MIL "ON" DTC P0A80 due to Dust or Debris in HV Battery Cooling Fan

Service Category Engine/Hybrid System

Section Hybrid/Battery Control System

YEAR(S)	MODEL(S)	ADDITIONAL INFORMATION
2011	Prius

Figure 2.

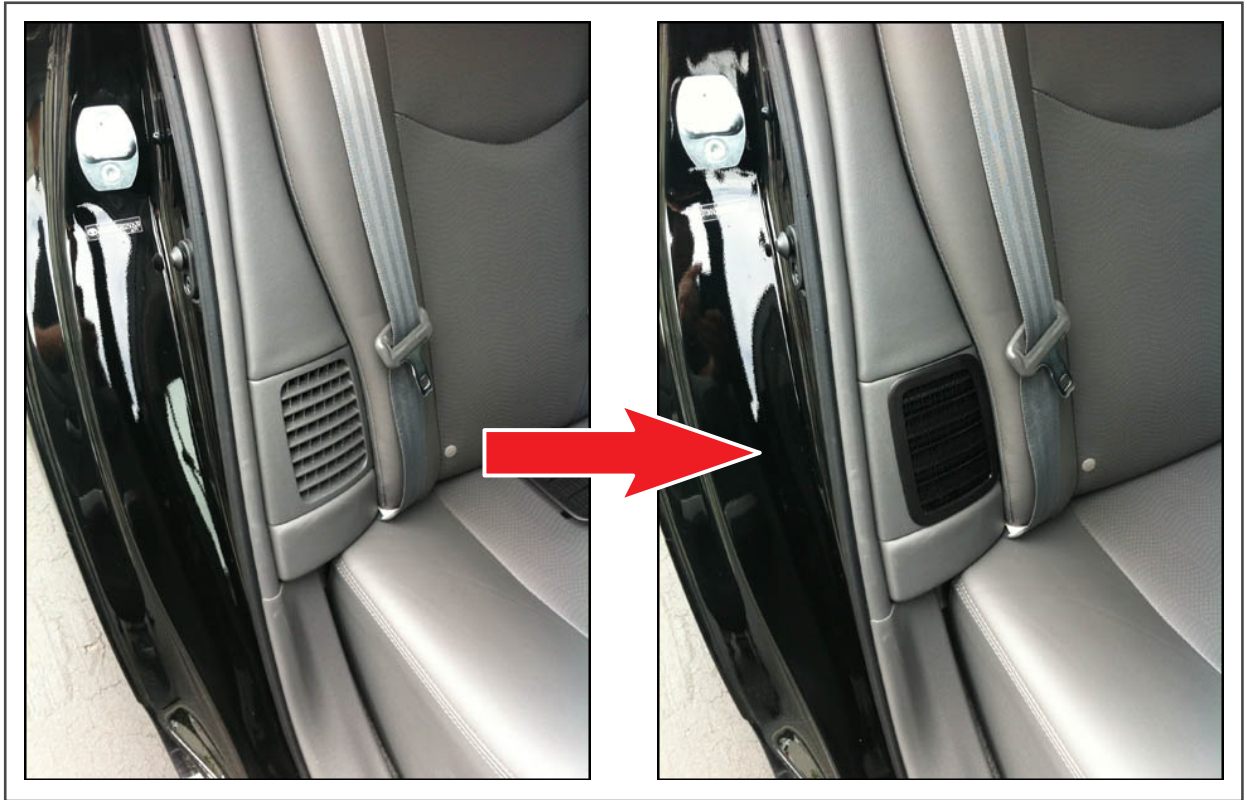
4. Install the HV Battery Cooling Fan Intake Filter as shown.

The filter should be cleaned when dust begins to appear on the surface.

Figure 3. Location of Authorized Modifications Label on 2011 Prius

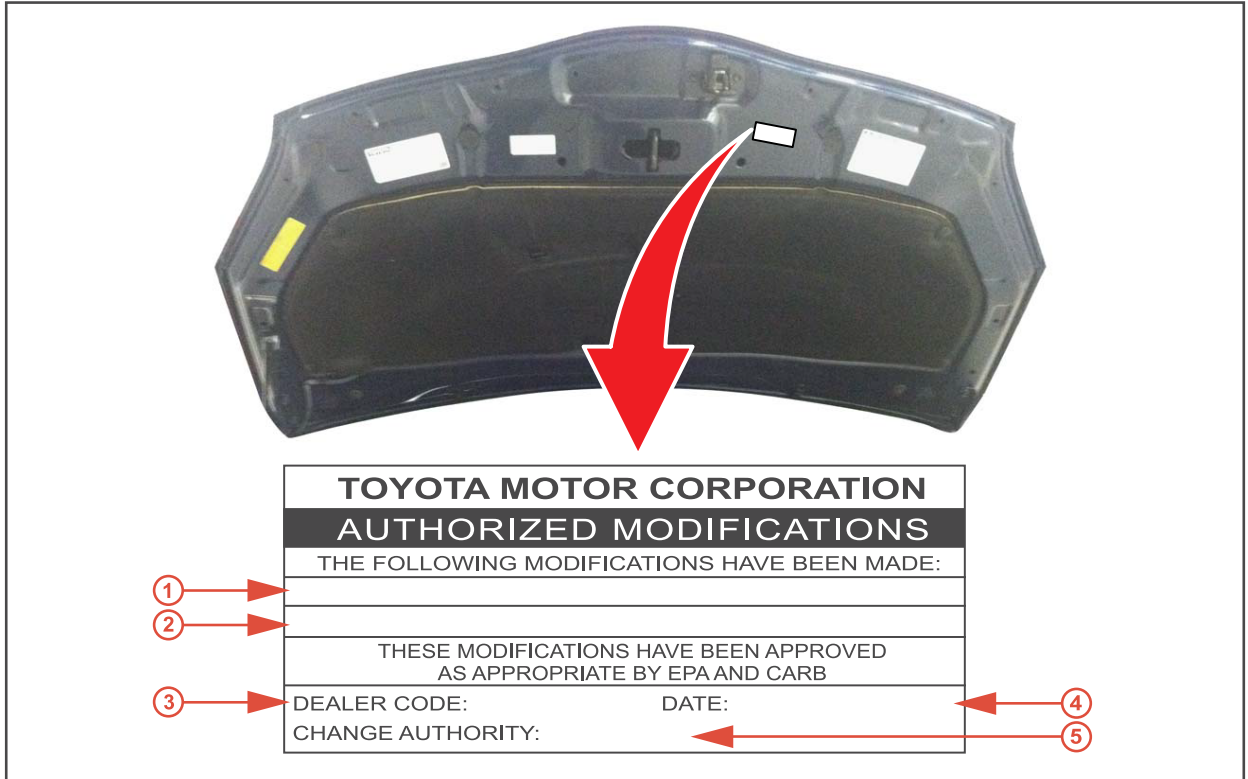
5. Check for the Authorized Modifications Label affixed to the vehicle in the location shown in Figure 3. Confirm if the Power Management ECU calibration has been updated. If the calibration ID listed is NOT the latest Power Management ECU calibration — go to step 6.
